The Victoria Road Area Residents' Association **objects** to the photographs used by the applicant for the Kensington Forum application (PP/18/03461) as "verified views" which have then been used to assess the impact of the proposed towers on views from the surrounding areas.

View 30: Victoria Road

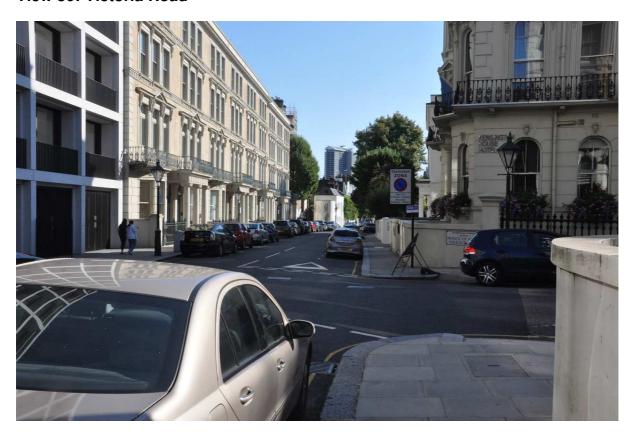
The use of a wide-angle lens has the effect of giving more emphasis to the foreground and for buildings in the background, pushing them further away and making them look smaller in relation to the foreground. This tends to minimise the scale of new buildings proposed when seen from a distance.

In this particular case the effect is very obvious because all photographs show the existing hotel building, which allows these "verified view" photographs to be compared with the reality that a person standing at the viewpoint can see. We are fortunate that it is possible to compare the wide-angle view with view as actually seen by a person standing in the street.

As you will see, there is a major difference – the impact of the existing building on the area is far more pronounced in the second photograph when compared with the one taken with the wide-angle (24mm) lens.

This demonstrates that the use of these "verified views" for the purpose of assessing the impact of tall buildings on the streetscape, townscape and long views is inappropriate – it is not fit for the purpose it is being asked to perform. It does not provide either the assessor or the decision maker with a realistic let alone accurate assessment of the impact.

The implications are that the current photographs should be heavily discounted or, preferably, not used to assess the impacts, and a new set of photographs at 50mm provided which more accurately reflect the perceived impact of the new buildings.
